Technical Service Bulletin

SUBJECT:			No: TSB-21-52A-002
EXCESSIVE INTERMITTENT MOVEMENT IN DRIVER'S POWER SEAT - REVISED			DATE: October 2021
			MODEL: 2007-19 Outlander, 2018-19 Outlander PHEV, 2011-19 Outlander Sport/RVR
CIRCULATE TO:	<input type="checkbox"/> GENERAL MANAGER	<input checked="" type="checkbox"/> PARTS MANAGER	<input checked="" type="checkbox"/> TECHNICIAN
<input checked="" type="checkbox"/> SERVICE ADVISOR	<input checked="" type="checkbox"/> SERVICE MANAGER	<input checked="" type="checkbox"/> WARRANTY PROCESSOR	<input type="checkbox"/> SALES MANAGER

This bulletin supersedes TSB-19-52A-004, issued October 2019, and updates the procedures to help resolve the power seat movement. Revisions are italicized and indicated by ◀.

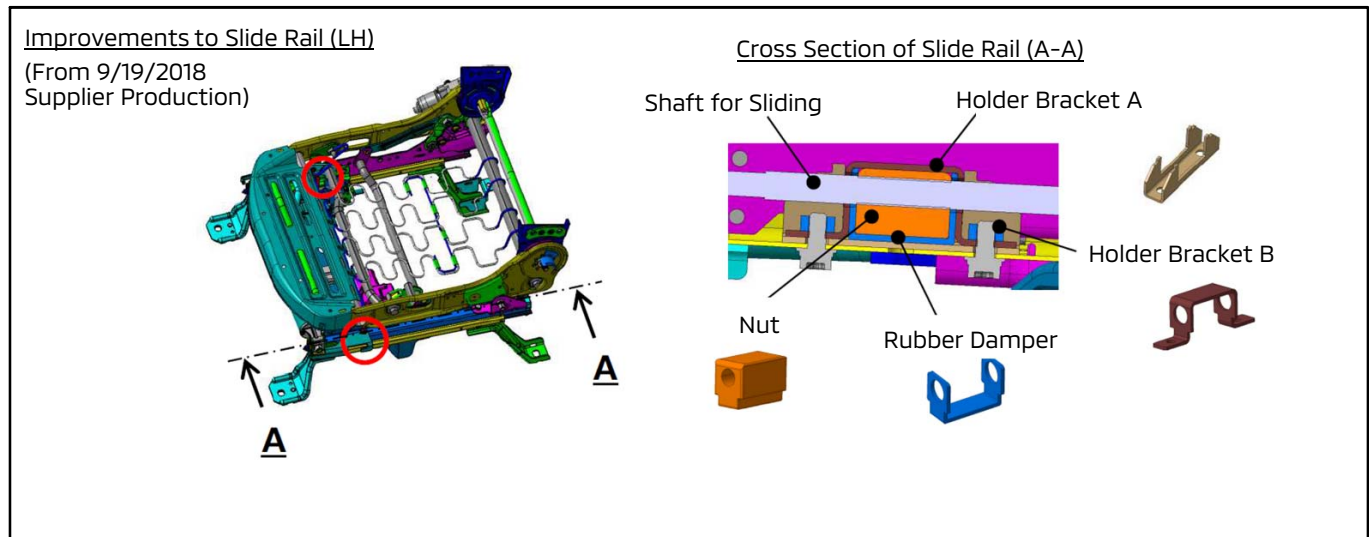
Height adjustment linkages in the seat adjuster assembly may loosen over time with normal driving and allow movement. A new seat adjuster was implemented in production at the supplier from March 2, 2016, and has added metal bushings at the 6 rotational connections on the seat frame, as shown below.

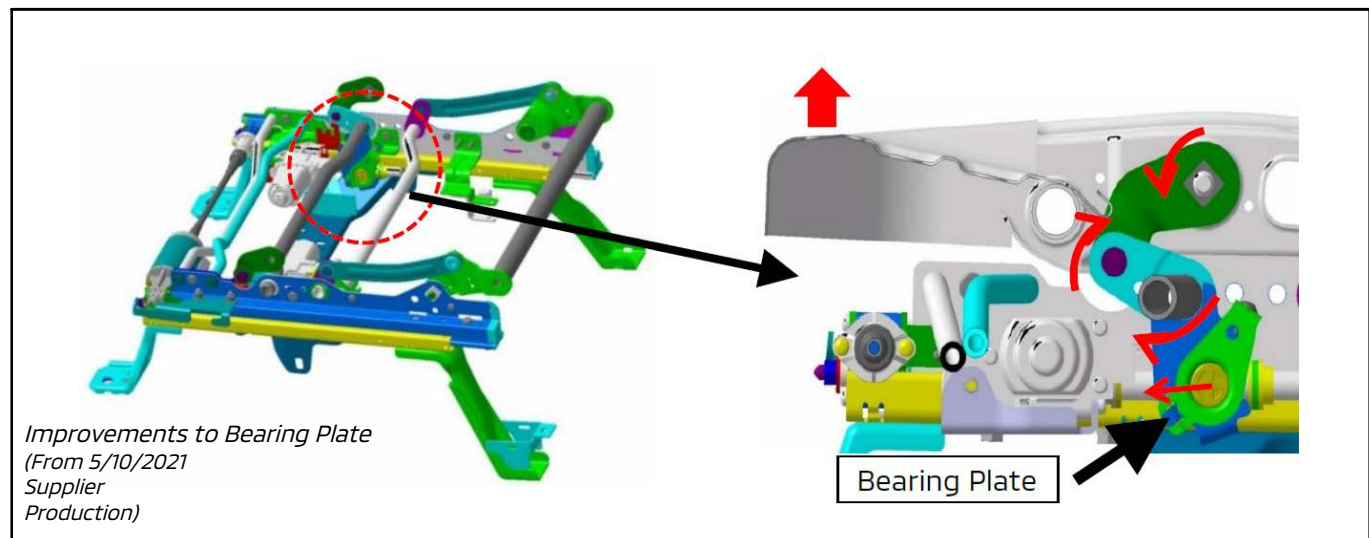
The clearance of the slide rail and rubber damper has also been changed in production at the supplier starting September 19, 2018. Refer to the VINs listed in Affected Vehicles.
